**(Product Change Notification)**

Wednesday, February 26, 2020

PCN# 21420

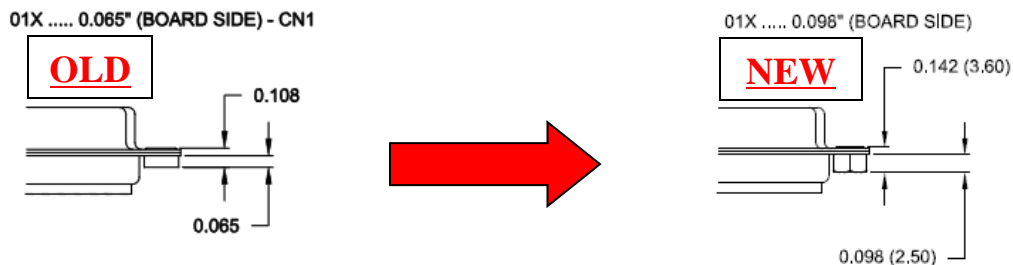
The hardware change pertains to shape and length. The shape of the hardware will now be a hex instead of a cylinder and the length of the parts will now be 0.098" instead of 0.065". Please see the illustrations below for a better understanding of the change.
